STATE OF VERMONT
AGENCY OF TRANSPORTATION

RECORD PLANS

VT ROUTE 12, MAJOR COLLECTOR BRIDGE NO : 25

PROJECT DESCRIPTION: REPLACEMENT OF BRIDGE 25 WITH MINOR CHANNEL AND APPROACH WORK.

TEST PAD

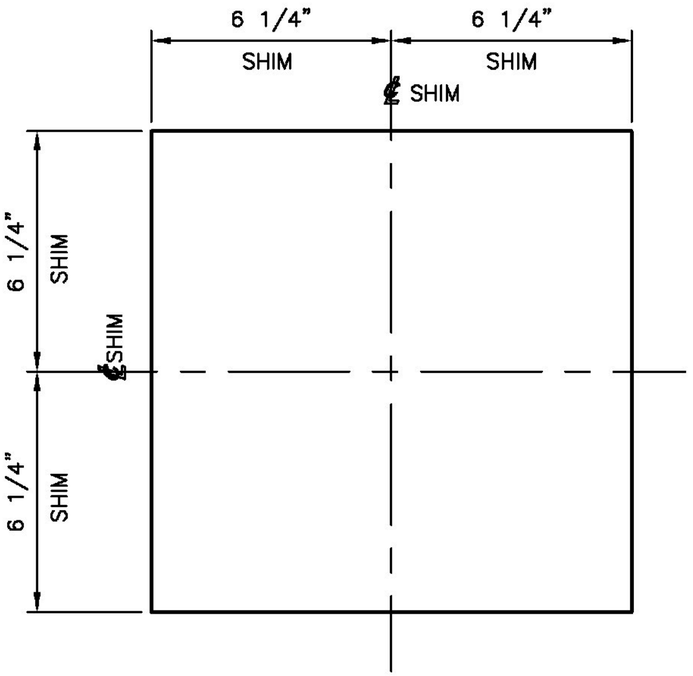
APPROVER PLEASE PROVIDE
LOAD CRITERIA FOR TESTING

Vermont Agency of Transportation
RECEIVED
CK'D BY WL OK'D BY JS
December 2, 2013
RESUBMIT NO Approved AsNoted
BY KH DATE 12-3-2013

ABUTMENT & WING WALL LAYOUT

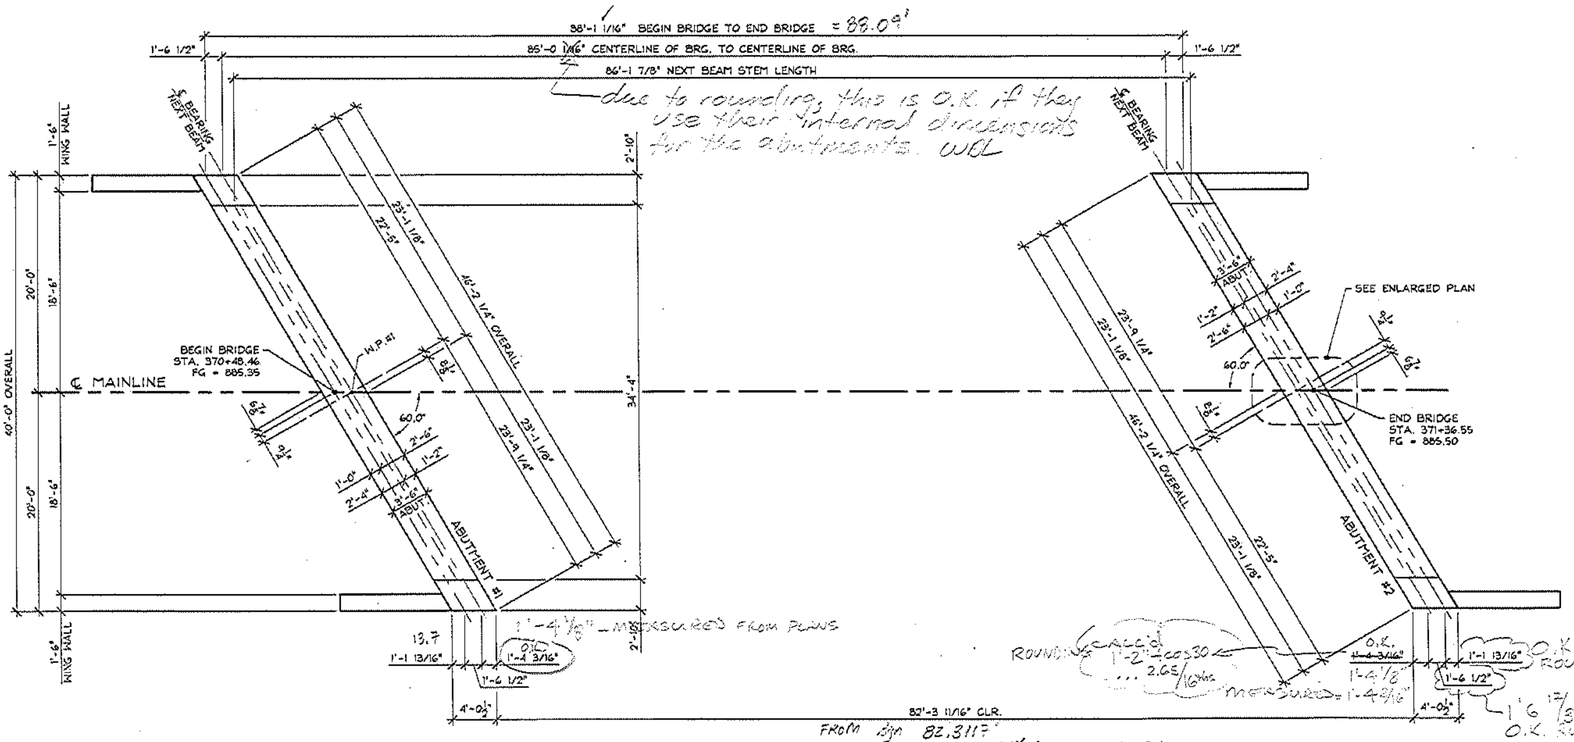
1/16" → 1/32" OFF ~ ROUNDING ISSUE

MEASURED FROM MICROSTATION:
85.0000' ON PLANS = 85'-0 1/16"
℄ - ℄

FROM CONTRACT PLANS
$\℄_{BRG} - \℄_{BRG} = (371+35.00) - (370+50.00) = 85'$
(BEG BRIDGE ↔ END BRIDGE) − (℄ BRG ↔ ℄ BRG) = 3' 1 1/16"
÷2
℄ BRG ↔ B/E BRIDGE = 1' 6 17/32"

ENLARGED PLAN

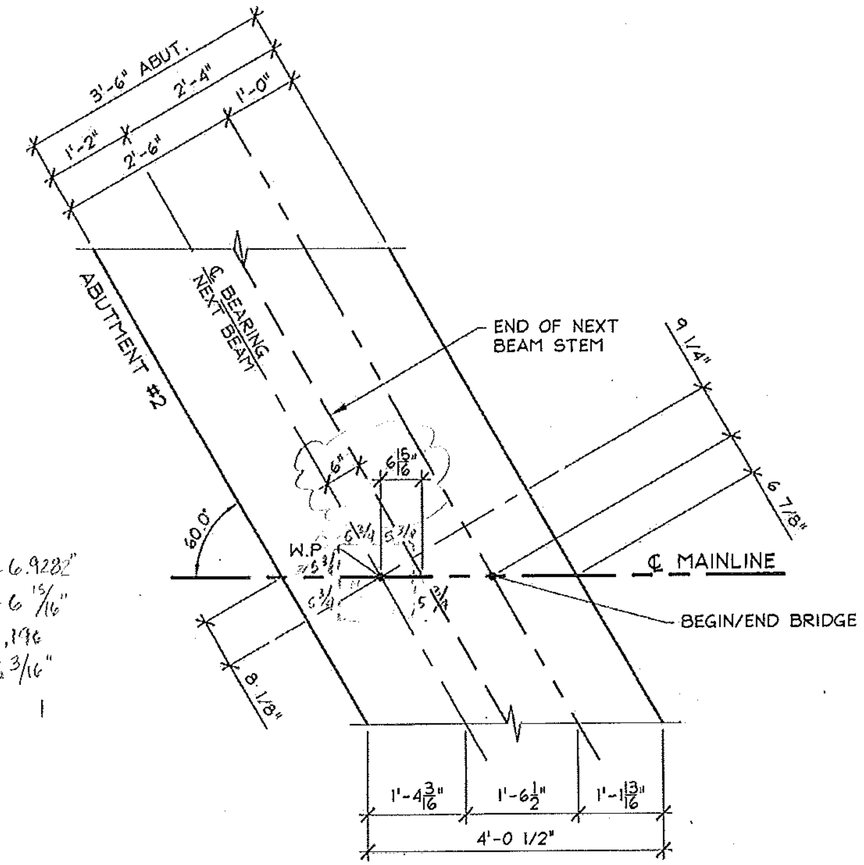
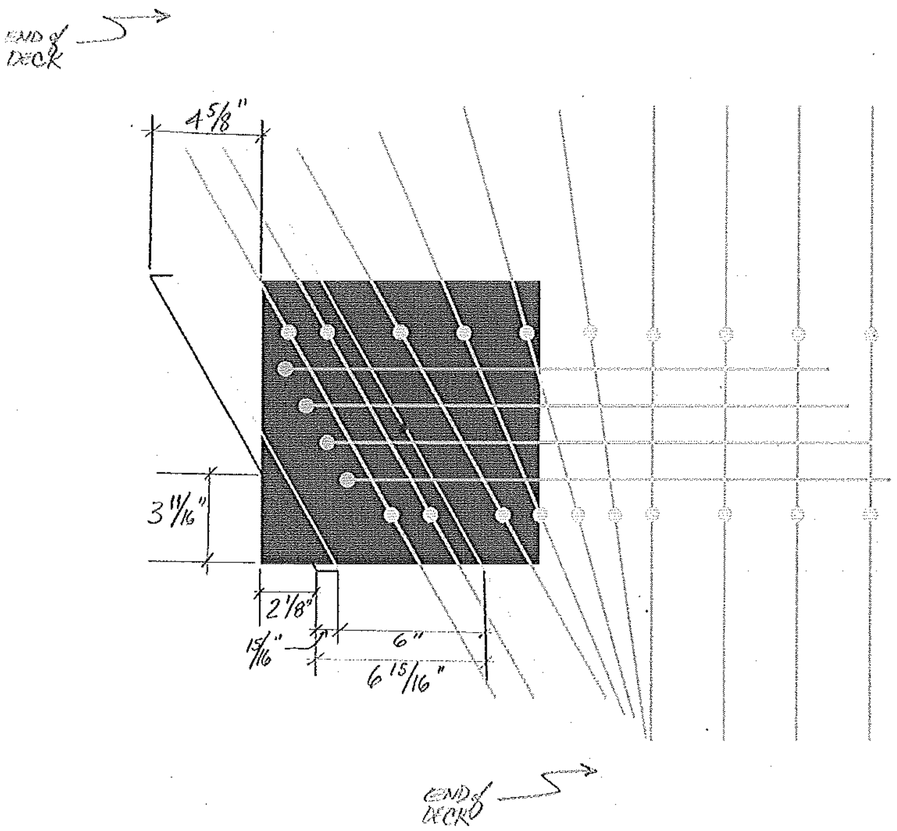
BEARING STILL STICKS OUT @ obtuse CORNER by 2 1/8"

CHECK AREA UNDER BEAM - SEE IF THAT SUPPORTS LOADS

$(11.5\,in)^2 - \frac{1}{2}(3\frac{11}{16}\,in)(2\frac{1}{8}\,in) =$
